Update Instructions

SP013/02/S

Title: Software Update

UROSKOP D2 / D3 with POLYDOROS SX.

Fig. 1

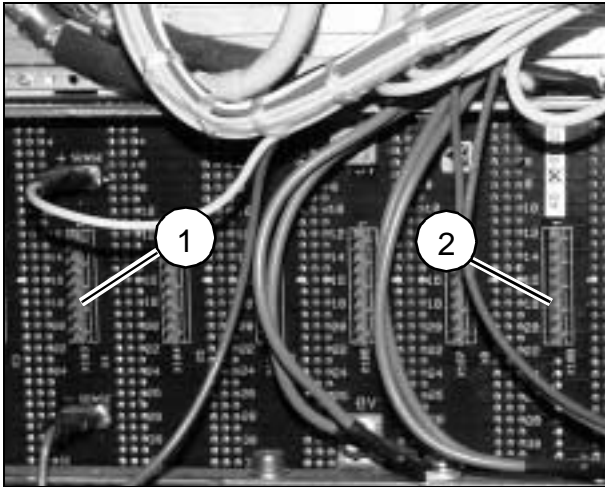
- Swivel out the control unit M20.
- Remove any EMC covers.
- Run the cables on the rear of the electronics frame from terminal strip X103 (1/Fig. 1) to terminal strip X108 (1/Fig. 2).
- When connecting the cables, make sure that they are not plugged in the wrong way round, e.g. connection from X103.7 to X108.7 and from X103.8 to X108.8.
- Reattach the EMC covers, swivel in the control unit and fasten it with screws.
- On PC board D3, solder the following wires (1/Fig. 2):
 - From terminal strip X1/c25 to X11/A3.
 - From terminal strip X1/c23 to X11/A2.
- Fit the PC board.
